# **U-turn detour route for 12.5m Medium Rigid Vehicle (MRV): Victory Parade, and Illoura Street - Northern Interchange, Newcastle Inner City Bypass, in Newcastle, NSW**

## **Traffic and Pedestrian Impact Study**

**Fulton Hogan**

**Project: RP2J – Newcastle Inner City Bypass**

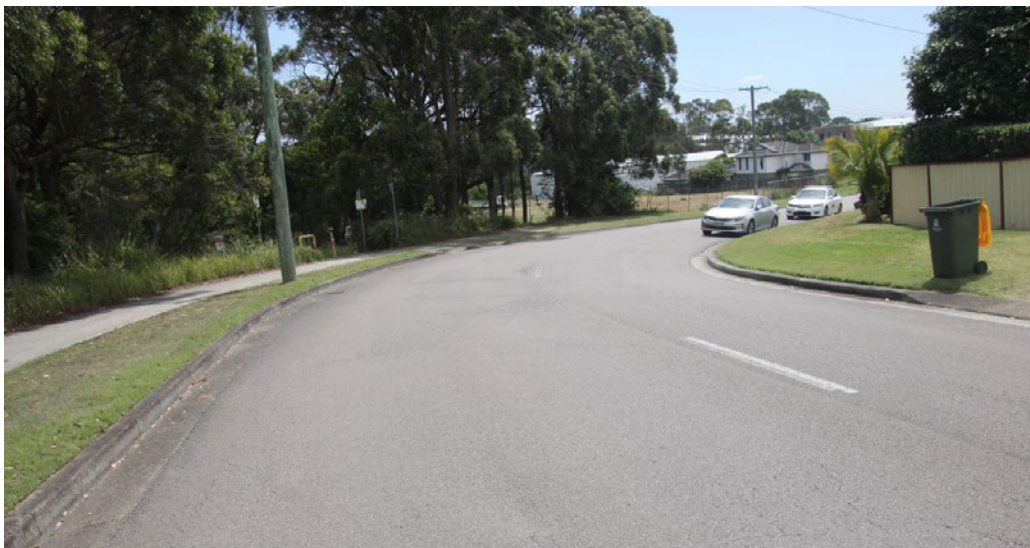
Photos and video footage of the audited site were taken (refer to Photos 3.1 & 3.2).

**Table 4.1: Road safety audit findings**

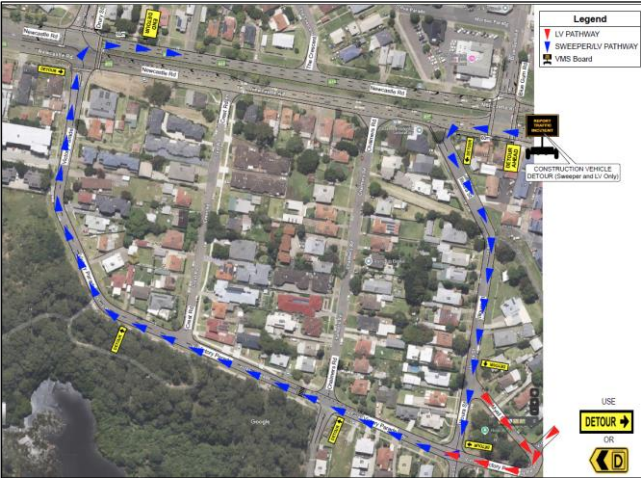
No.	Approximate location	Description of findings
1	Newcastle Road, Illoura Street, and Victory Parade	<p>'DETOUR' (T5-1) sign and 'DETOUR AHEAD' (T1-1) signs are missing on Newcastle Road, Illoura Street, and Victory Parade.</p> <p>In addition, nothing is in place to warn drivers of a detour or to identify the directions and locations for their trucks to leave Newcastle Road.</p> <p>The 'DETOUR' (T5-1) sign should be used along the route to reassure and guide the construction HVs on the detour route.</p> <p><b>Recommended mitigation measures:</b></p> <ul style="list-style-type: none"> <li>Install 'DETOUR AHEAD' (T1-1) and 'DETOUR' (T5-1) signs and repeat the 'DETOUR' (T5-1) signs to reassure and guide the 12.5m long Medium Rigid Vehicle (MRV) along the route of the detour (refer to Figure 4.1).</li> </ul>  <p><b>Figure 4.1</b></p>

No.	Approximate location	Description of findings
2	Newcastle Road, Illoura Street, and Victory Parade  / Swept path analysis	<p>Swept path analysis leads to the conclusion that the proposed U-turn detour route is wide enough to accommodate swept paths of 12.5m long Medium Rigid Vehicle (MRV) (refer to Figure 4.2).</p>  <p><b>Figure 4.2</b></p>

No.	Approximate location	Description of findings
6 Cont'd		 <p><b>Figure 4.3</b>        (Source: nearmap)</p>

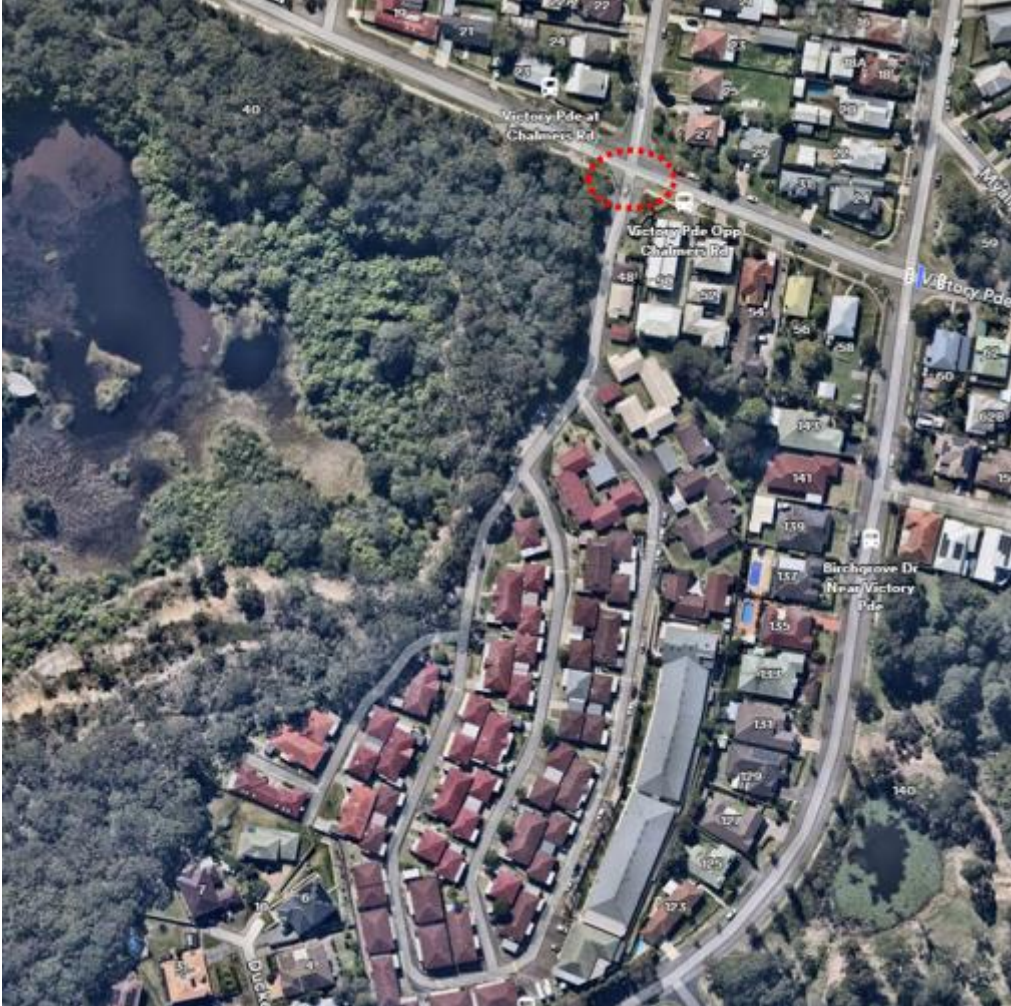
No.	Approximate location	Description of findings
6	Victory Parade, at the intersection with Chalmers Road and the access driveway to the retirement village	<p>The access driveway to a retirement village is located at the intersection with Chalmers Road (refer to Photo 4.7 and Figure 4.3).</p>  <p><b>Photo 4.7: Access driveway to the retirement village, off Victory Parade</b>          (Photo: Streetview)</p>

No.	Approximate location	Description of findings
6 Cont'd		<p>As observed at the site, in all likelihood and foreseen circumstances, the access driveway and a vehicle on it are visible to a driver on Victory Parade at least 70m before the intersection (refer to Photo 4.8 and Figure 4.4).</p> <div data-bbox="611 430 1865 790">  </div> <p><b>Photo 4.8: Victory parade, at <math>\approx</math> 70m before the intersection with the access driveway to the retirement village</b>            (Photo: Traffic Engineering Centre Pty Ltd)</p> <div data-bbox="611 869 1865 1319">  </div> <p><b>Figure 4.4</b>            (Source: nearmap)</p>

No.	Approximate location	Description of findings																							
6 Cont'd		<p>Considering the general minimum reaction time (<math>R_t</math>) of only 2.0 seconds, the available minimum Stopping Sight Distance of 70m complies with the minimum standard requirements (refer to Table 4.2).</p>
